STAFF RECOMMENDATION
3603 Central Avenue
April 17, 2019

Application: New Construction—Addition
District: Richland-West End Neighborhood Conservation Zoning Overlay
Council District: 24
Base Zoning: RS7.5
Map and Parcel Number: 10405030400
Applicant: Robert Riley
Project Lead: Melissa Sajid, melissa.sajid@nashville.gov

<p>Description of Project: The application to construct an upper level addition behind the main ridge of the house and to construct a screened porch addition.</p> <p>Recommendation Summary: Staff recommends approval with the following conditions:</p> <ol style="list-style-type: none">1. The upper level part of the addition on the right side shall set in two feet (2') from the existing side wall of the historic house;2. Staff approve the final details of all materials prior to purchase and installation; and,3. If relocated, the HVAC shall be located behind the house or on either side, beyond the mid-point. <p>With these conditions, staff finds that the project meets Section II.B of the <i>Richland-West End Neighborhood Conservation Zoning District: Handbook and Design Guidelines</i>.</p>	<p>Attachments A: Site Plan B: Elevations C: Letter from owner D: Photos</p>
---

Figure 1. 3603 Central Avenue

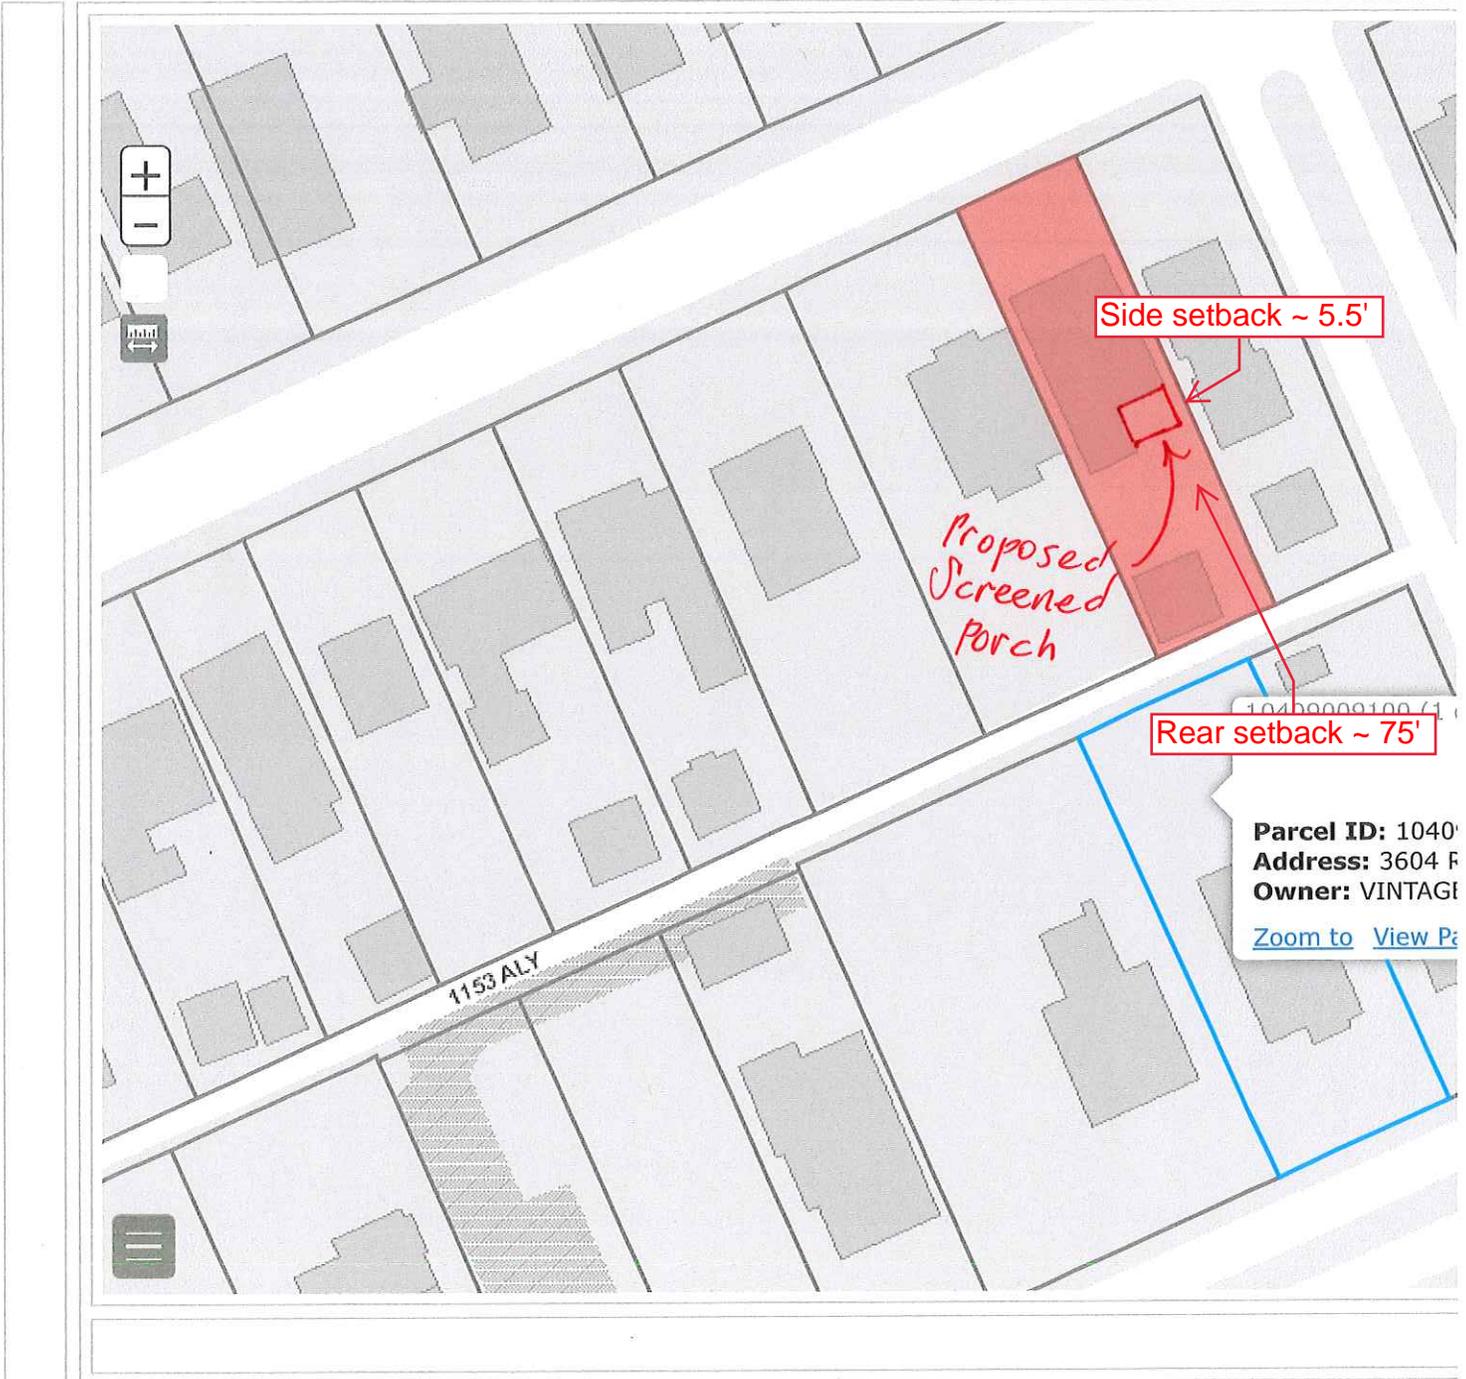
Background: The house located at 3603 Central Avenue is a one and one-half story bungalow that was built c. 1915 and contributes to the character of the Richland-West End Neighborhood Conservation Zoning Overlay (Figure 1).

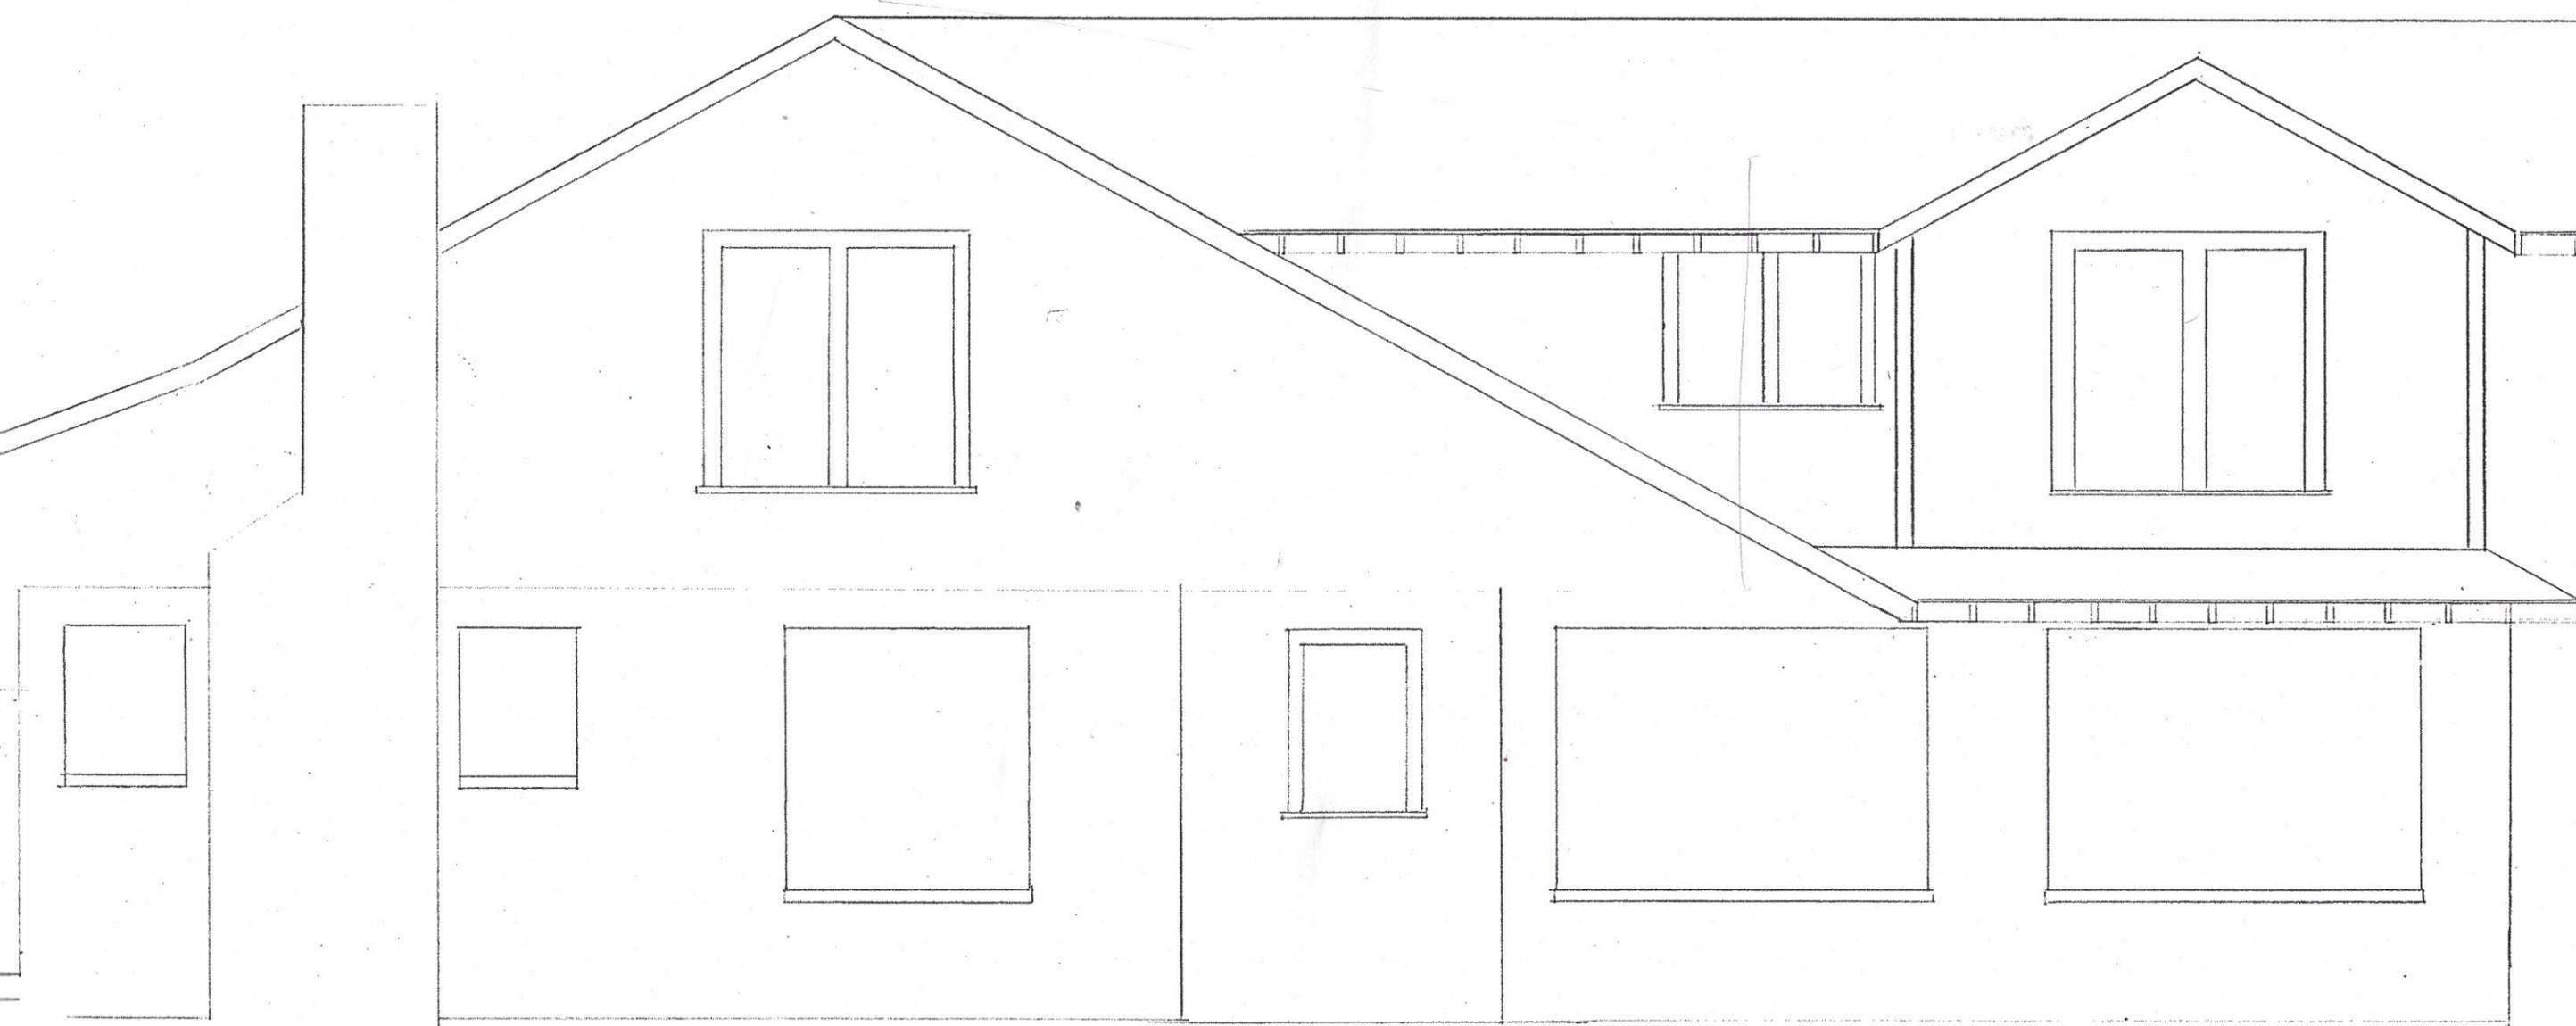
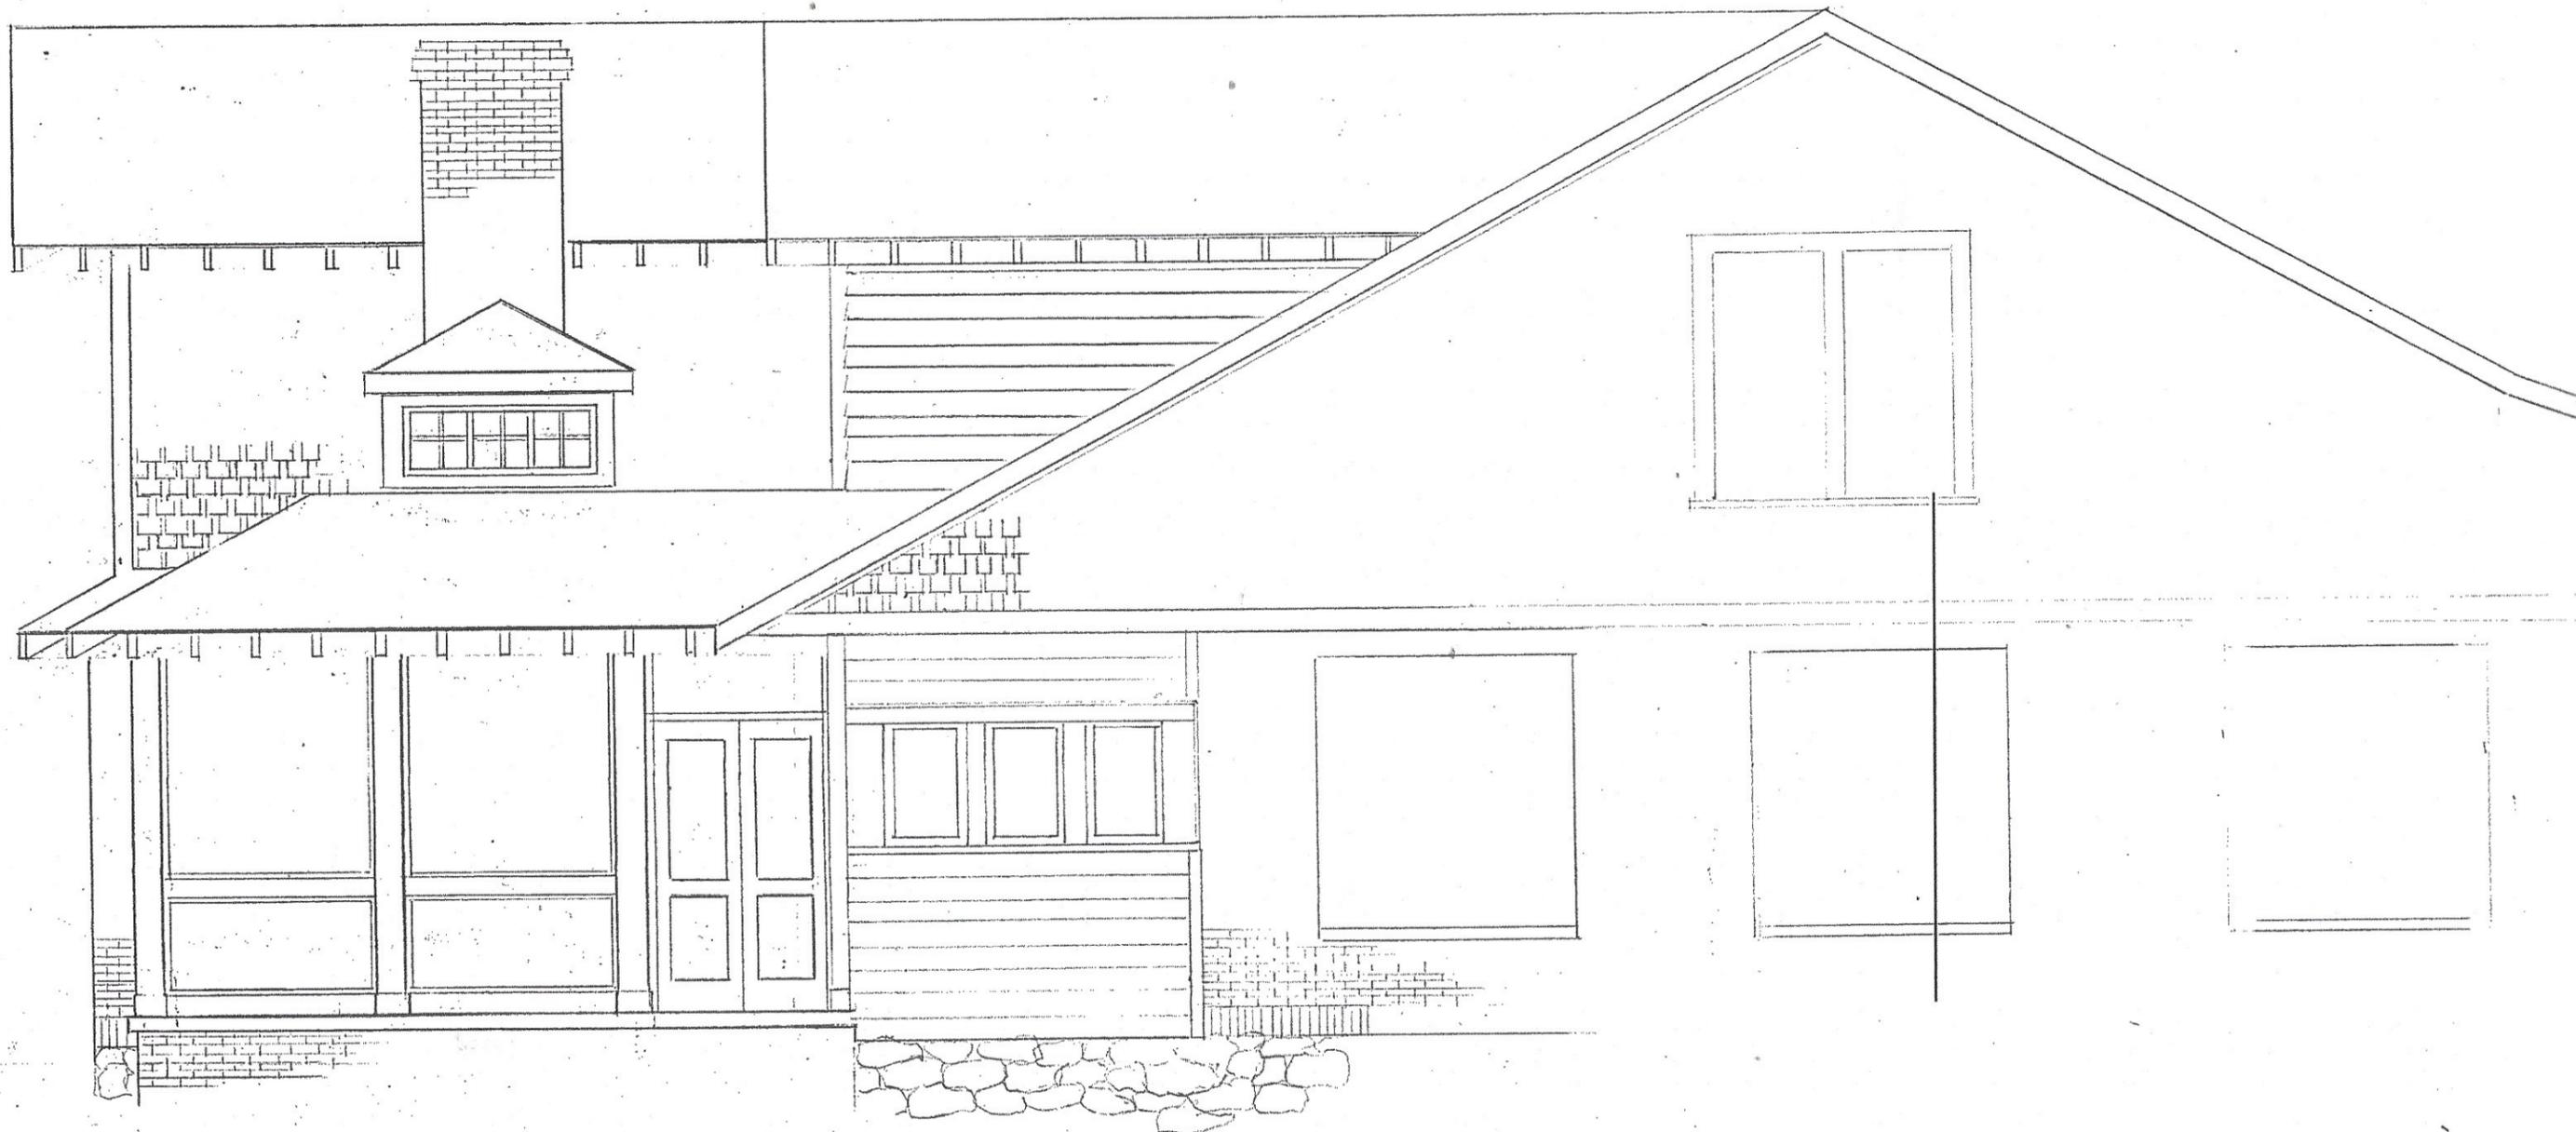
The upper level addition on the right side, however, is only set in four inches (4"). The four inch (4") inset created by the difference in the depth of materials does not meet the design guideline that requires additions to set in one foot (1') per story. The purpose of this guideline is to help distinguish the new construction from the historic house, to ensure that the massing of an addition doesn't overwhelm the historic building, and to make it so that if the addition were to be removed in the future the historic house would still be intact. For these reasons, staff finds that the height of the addition could be appropriate if it were set in appropriately on the right side.

With the condition that the upper level part of the addition on the right side set in two feet (2') as required by the design guidelines, staff finds that the additions' height and scale meet Sections II.B.1.a., II.B.1.b., and II.B.2. of the design guidelines.

1. The upper level part of the addition on the right side shall set in two feet (2’) from the existing side wall of the historic house;
2. Staff approve the final details of all materials prior to purchase and installation; and,
3. If relocated, the HVAC shall be located behind the house or on either side, beyond the mid-point.

To step the new rooms in 2 feet on the right as the commission has requested would create a significant hardship. It would require significant expense in structural steel or deep laminated beams, and the space lost from those two rooms will greatly compromise the function and comfort of the addition.

In consideration of these factors we ask that the addition be permitted to be built as drawn
